L-2012-297
10 CFR 52.3

Re: Florida Power & Light Company
Proposed Turkey Point Units 6 and 7
Docket Nos. 52-040 and 52-041
Response to NRC Request for Additional Information Letter No. 61 (eRAI 6432)
Related to SRP Section 03.07.01 - Seismic Design Parameters

NRC RAI Number: 03.07.01-19 (eRAI 6432)

**Figure 2.5.2-249 Median Profiles of Strain-Compatible Soil Damping
(Upper 800 feet) (Sheet 2 of 2)**

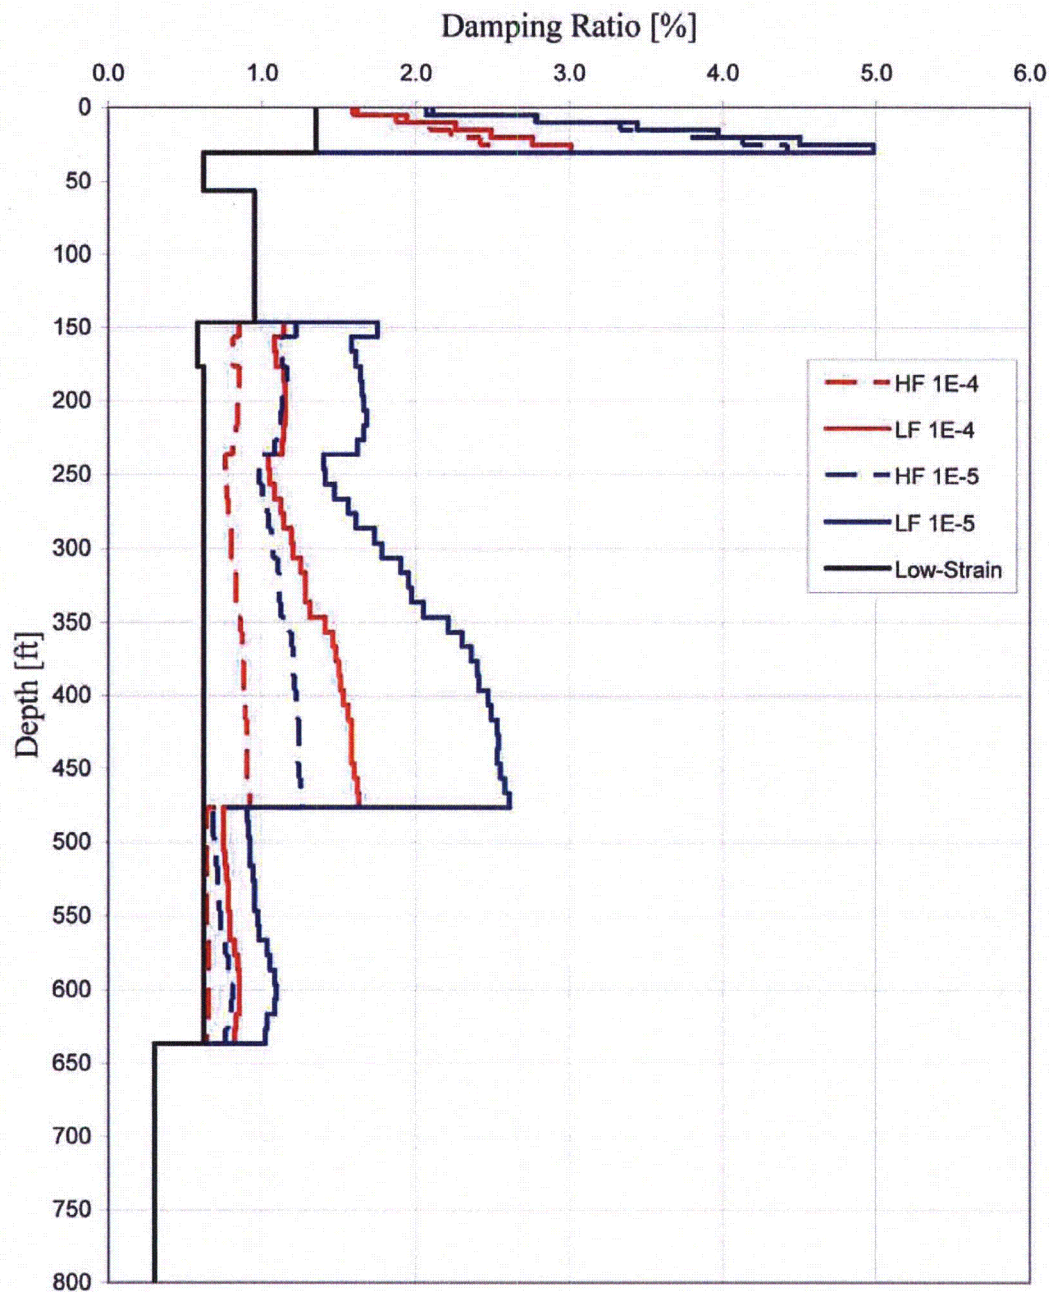
In Revision 3 of the applicant's FSAR, (aka. TPG-1000-S2R-802, "Turkey Point Site-Specific Seismic Evaluation Report") the third paragraph in Section 2.5.4.7.3.3, "Shear modulus and Damping for Rock," states that the damping for rock is taken as 1%. The damping shown in Figure 2.5.2-249 which describes the soil properties used to develop the GMRS indicates that a damping value of ½% was used in the analyses. The applicant is requested to provide clarification as to the actual level of damping used in the analyses, including the SSI analyses, and provide basis for selection considering the large variability in RQD shown in Figure 2.5.4-215.

FSAR Figure 2.5.2-249 (Sheet 2 of 2) is reproduced in this response for illustrative purposes. This figure represents the full soil and rock column that includes approximately 30 ft of structural fill (with surface at El. +25.5 ft NAVD 88) above approximately 25 ft of Miami Limestone, overlying about 90 ft of rock consisting of the Key Largo and Fort Thompson Formations. The rock is underlain by soil of the Tamiami and Peace River Formations to about 475 ft depth. The Arcadia Formation, consisting of very weak rock mixed with some soil extends to about 640 ft depth, the limiting depth of the site subsurface investigation. The actual levels of damping used in the analyses are the values shown in FSAR Figure 2.5.2-249 (Sheet 2 of 2). The basis for selecting the value for each formation is described in the following paragraphs.

FSAR Subsection 2.5.4.7.3.3 indicates that the Miami Limestone is considered sufficiently weak to have strain-dependent modulus and damping values. FSAR Table 2.5.4-216 shows the damping ratio (D, percent) versus shear strain values. D remains constant at 0.6 percent from 0.0001 to 0.03 percent strain. In the SHAKE analysis, shear strain did not exceed 0.03 percent, and so D is constant at 0.6 percent in FSAR Figure 2.5.2-249 (Sheet 2 of 2). D = 1 percent at all strain levels for the Key Largo and Fort Thompson Formations (Strata 3 and 4) as stated in FSAR Subsection 2.5.4.7.3.3, which notes that damping in these formations is not strain dependent.

The only other rock formation noted in FSAR Subsection 2.5.4.7.3.3 is Stratum 8, the Arcadia Formation. This formation is included with the Key Largo and Fort Thompson Formations in FSAR Subsection 2.5.4.7.3.3 as being non-strain-dependent and having D constant at 1 percent. The Arcadia Formation is much weaker than the Key Largo and Fort Thompson Formations. FSAR Table 2.5.4-209 indicates an unconfined compressive

strength of 100 psi compared with 1,500 and 2,000 psi for the Key Largo and Fort Thompson Formations, respectively. Even the strain-dependent Miami Limestone has double the strength of the Arcadia Formation. Thus, for the Arcadia Formation, consideration was given to using the D versus shear strain values of the Miami Limestone (Oolite) given in FSAR Table 2.5.4-216. However, since the Arcadia Formation is the lower portion of the Hawthorn Group, with the overlying Peace River Formation (FSAR Subsection 2.5.1.1.1.2.1.1) forming the upper portion, it was considered more appropriate to use the D versus shear strain values of the Peace River Formation for the Arcadia Formation. FSAR Subsection 2.5.4.7.3.2 will be modified to indicate that the Peace River Formation damping values are also used for the Arcadia Formation. (FSAR Subsection 2.5.4.7.3.1 will be similarly modified to address shear modulus degradation curves.)

The constant damping ratio of the material below the Arcadia Formation, (i.e., below about 640-ft depth in FSAR Figure 2.5.2-249, Sheet 2 of 2), is 0.32 percent based on the median value of kappa and associated uncertainty.

The damping ratio versus shear strain relationship derived for mudstone was selected for the Miami Limestone, and the damping ratio versus shear strain relationship for natural soil measured from RCTS testing was selected for the Arcadia Formation (both relationships are shown on FSAR Figure 2.5.4-235). The strength and rigidity of the limestone in the Key Largo and Fort Thompson Formations indicated that damping ratio is independent of strain level, and a value of 1 percent was selected, consistent with the damping ratio selected for other rock sites (e.g., North Anna Unit 3 and VC Summer Units 2 & 3). The following provides a basis for the selection of damping ratio values for the various rock strata considering the large variability in RQD shown in FSAR Figure 2.5.4-215. Each rock stratum is defined based on age, mineral composition, depositional mode, etc. Although there may be significant variability of a parameter (strength, shear wave velocity, RQD, etc.) within a stratum, a single damping ratio versus strain relationship is selected for each stratum. If the variability was clearly defined within the stratum (e.g., high RQD at the top of the stratum and low RQD at the bottom), the stratum could be sub-divided into separate strata and different damping ratio versus strain relationships assigned to each. However, with the Turkey Point rock strata, the variability is generally random, and the strata are not sub-divided.

The uncertainties and variation in the damping ratios (reflected in the variations in parameters such as RQD) were taken into account in the randomization process. FSAR Figure 2.5.2-238 shows the variation assumed in the randomization process for the damping ratio versus strain for the Arcadia Formation.

This response specifies the level of damping used in the generation of simulated (randomized) soil profiles, which are in turn used in seismic site response analysis. The SSI analyses use the strain-compatible damping ratios that result from the site response analysis of the simulated (randomized) profiles. FSAR Table 3.2-1 in Appendix 3KK provides the damping ratio values used in the SSI for the best estimate profile.
